HISTORIC AND DESIGN REVIEW COMMISSION

November 15, 2017

HDRC CASE NO: 2017-567
ADDRESS: 729 N PINE ST
LEGAL DESCRIPTION: NCB 549 BLK 9 LOT S 10 FT OF ARB A 13 & N 40 FT OF ARB A 12
ZONING: RM-6
CITY COUNCIL DIST.: 2
DISTRICT: Dignowity Hill Historic District
APPLICANT: Aaron Morosini
OWNER: Jason Conine
TYPE OF WORK: Remove ribbon driveway and install roadbase/decomposed granite
APPLICATION RECEIVED: October 27, 2017
60-DAY REVIEW: December 26, 2017

The applicant is requesting a Certificate of Appropriateness for approval to remove the existing concrete ribbon driveway to install a roadbase and decomposed granite driveway.

729 N. Pine

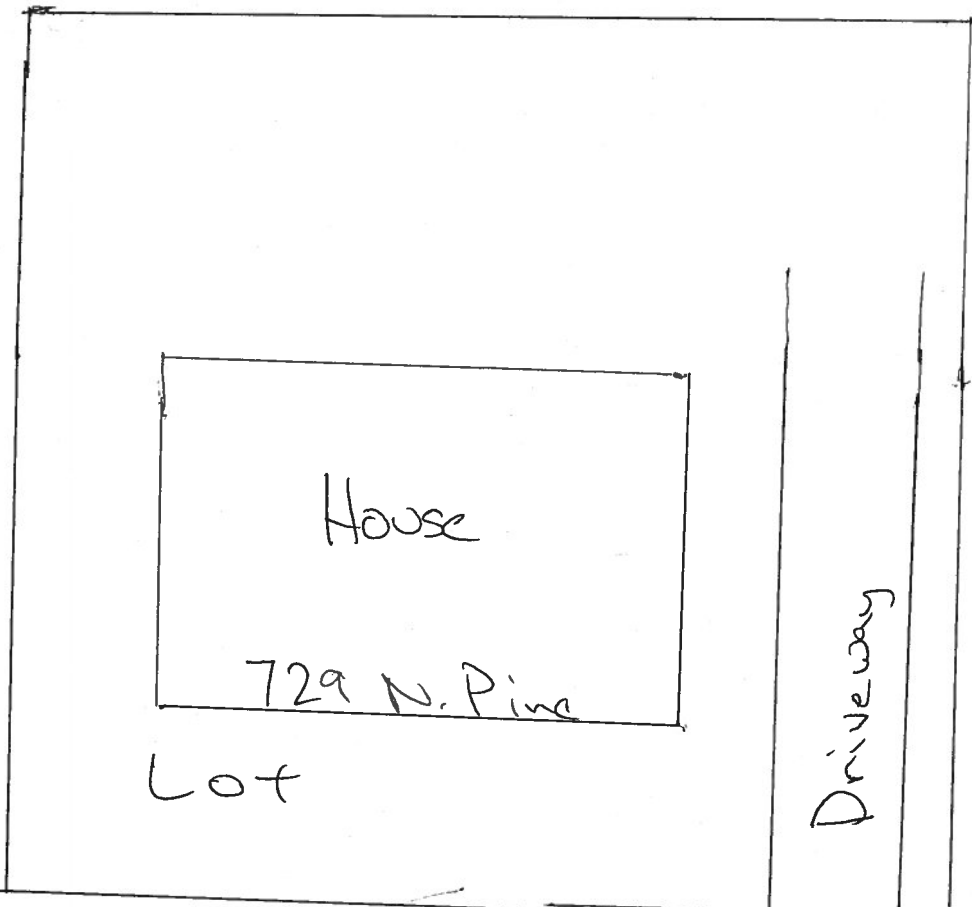
- b. The applicant has proposed to remove the existing concrete ribbon driveway to install a new driveway featuring roadbase and decomposed granite. The Guidelines for Site Elements notes that driveway configurations – material, width, and design – must be retained or repaired on historic properties, while pervious paving surfaces may be considered where replacement is necessary to increase stormwater filtration. The ribbon configuration is present on 8 of the 10 applicable properties on the N Pine Block between cross streets Nolan and Burnet; the other two driveways feature gravel and concrete. Staff does find the proposal to remove the ribbon configuration consistent with the Guidelines. Pervious paving can be considered for the center strip of grass between the concrete ribbons.

Staff does not recommend approval to remove the concrete ribbon driveway based on finding b. Pervious paving or gravel may be considered for the center strip of grass between the concrete ribbons.
